Newport City Council – Planning Consultation

Application Number: 25/1004

Proposal: DEMOLITION OF THE FORMER DAYCARE CENTRE BUILDINGS AND THE CONSTRUCTION OF 6 NO DWELLINGS, ACCESS ROAD, TURNING AREA AND ASSOCIATED WORKS

Arboricultural Remarks.

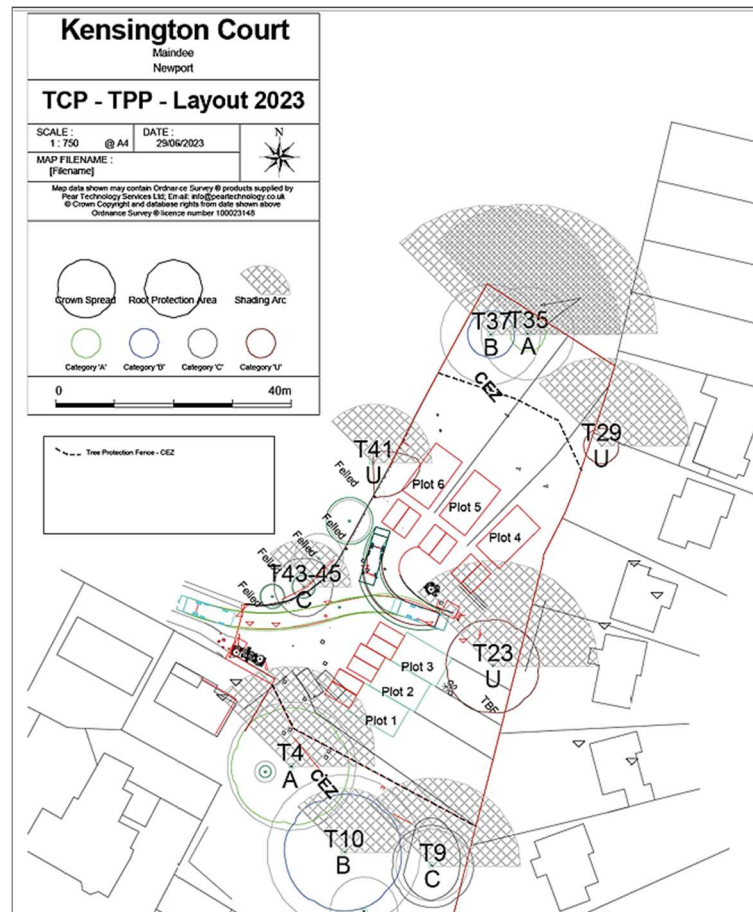
6. T23 – do we have photographic evidence of its condition, to support the removal of this protected tree, under the 'dead, dying or dangerous' exemption or U category rating ?

I' m afraid the undated, silhouetted photograph provided does not clearly show 50% crown dieback. Unfortunately I am not privy to previous discussions held with NCC and I do not see any evidence to support this. Please can your current arborist inspect this tree and confirm its condition and show the crown dieback now that the trees are in leaf..

No, only T23 is to be removed as it is 50% dead. This has been confirmed as being acceptable by Newport Council previously during discussions about the site and trees.

Please see photo below
